# Preliminary Plat
# Rivers Crossing Addition

November 14, 2016

**REF.: "Preliminary Plat of the Rivers Crossing Addition to the City of Waco, McLennan County, Texas"**

# PRELIMINARY PLAT
# RIVERS CROSSING ADDITION
# CITY OF WACO, MCLENNAN COUNTY, TEXAS

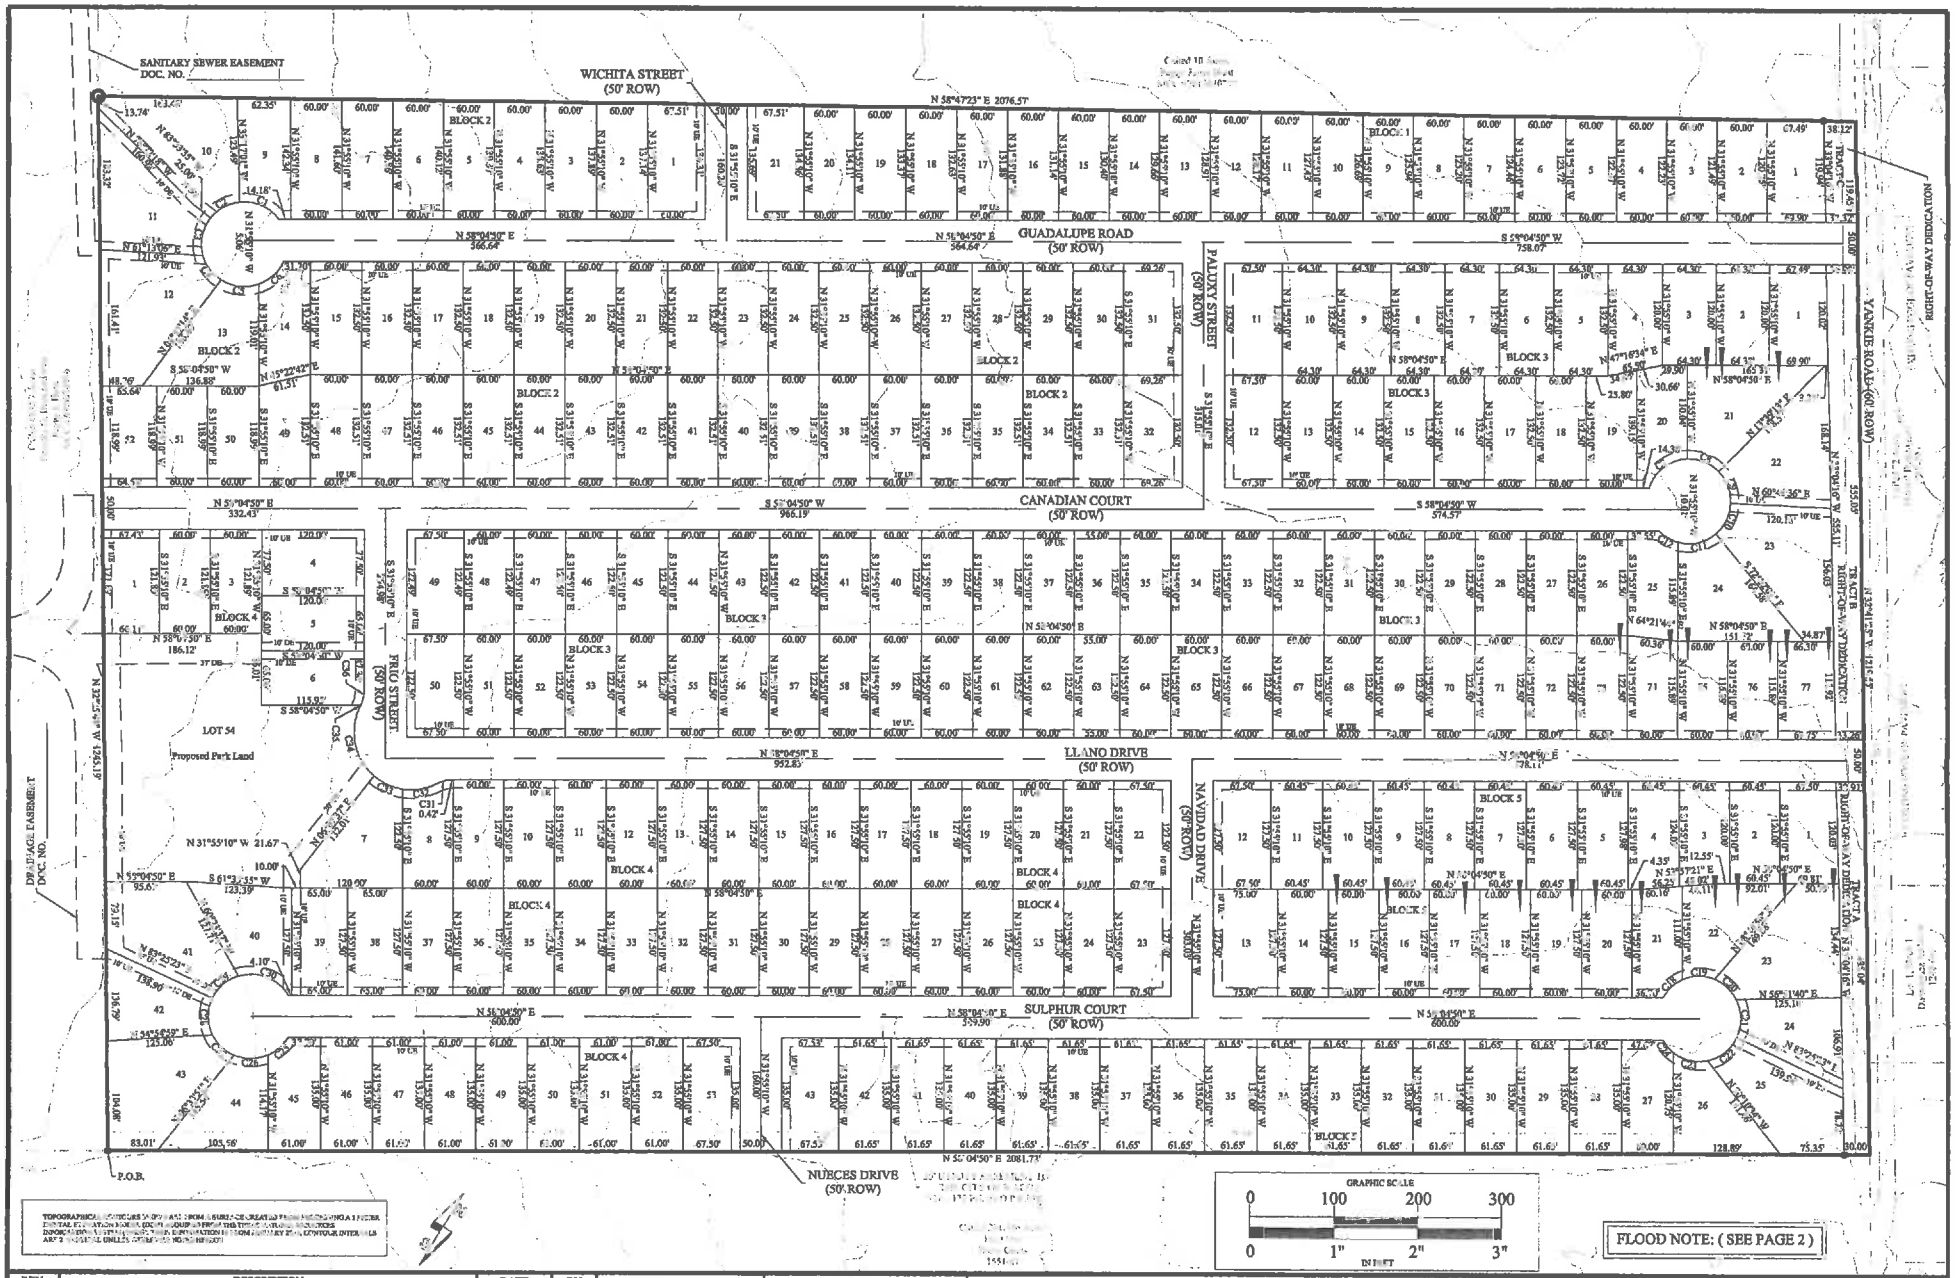
1. The owner of the property needs to sign the plat.
2. A note on the plat must be added stating "The acceptance of the offer of the proposed park land dedication must be by ordinance approved by the Waco City Council per Section 5.203 of the Subdivision Ordinance. No plat offering dedication shall be filed for record unless and until the City Council has accepted the dedication by ordinance."

3. A comprehensive drainage plan has been submitted and is under review. The submitted plan must meet the current City of Waco Drainage Policy and offsite easements may be needed for proposed public drainage improvements. Any required off-site drainage easements must be obtained prior to the final plat being approved and recorded. Also, those easements should be granted to the City of Waco. Include on the plat, recording information for off-site drainage easements.

4. Plan and specifications for streets, sidewalk, drainage, and utility improvements for this addition have been submitted and are under review. Construction of these improvements must be in conformance with all applicable city ordinances and the approved plans.

5. Submit plans and specifications for the construction of traffic calming devices along the proposed Guadalupe, Llano & Canadian streets in accordance with the approved sketch submitted to Traffic Services on 10/10/2016. Construction of these traffic calming devices must be in conformance with all applicable city ordinances and the approved plans.

6. A Traffic Impact Analysis for the subdivision has been submitted and is under review. Based upon this review, the owner may be required to pay a portion of the costs for additional street and traffic improvements which is roughly proportionate to the impact of the proposed subdivision or construct additional street and traffic improvements which are roughly proportionate to the impact of the proposed subdivision. A staff response will be provided to the applicant per the Traffic Impact Analysis Guidelines for the City of Waco. Construction of these required additional street and traffic improvements must be in conformance with all applicable city ordinances and the approved plans.
